Product/Process Change Notice

Jetson TX1 and Jetson TX2

Update Japan Ministry of Information and Communication (MIC) Type Certification Number

January 14, 2020 | PCN205103

Revised Jetson TX1 (P2180) Label

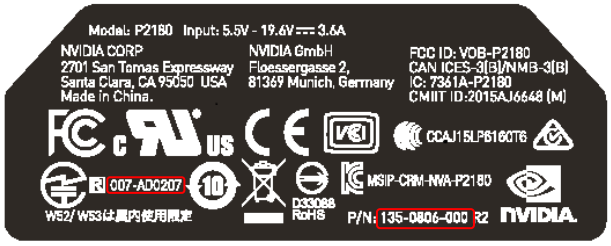
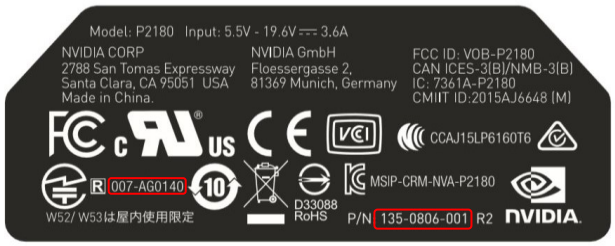
V1	September 11, 2018	Issued PCN about updated MIC Type Certification Number on TX1 and TX2 labels.
V2	January 14, 2020	Corrected the Revised label images on page 3. In V1 of this PCN, each image correctly showed the updated MIC Type Certification Number, but incorrectly did not show that the label's Part Number was also updated. The corrected images now include the updated label Part Numbers.

NVIDIA Jetson TX1 and Jetson TX2 modules will have a new MIC Type Certification Number.

NVIDIA Wi-Fi firmware for Jetson TX1 and Jetson TX2 does not currently enable band W56 in Japan. Initial certification from Japan incorrectly enabled band W56 during compliance testing. NVIDIA has obtained new MIC Type Certification Numbers for these two products which correctly align the official certifications with the already shipping firmware.

The MIC number can be seen on the module labels as shown below.
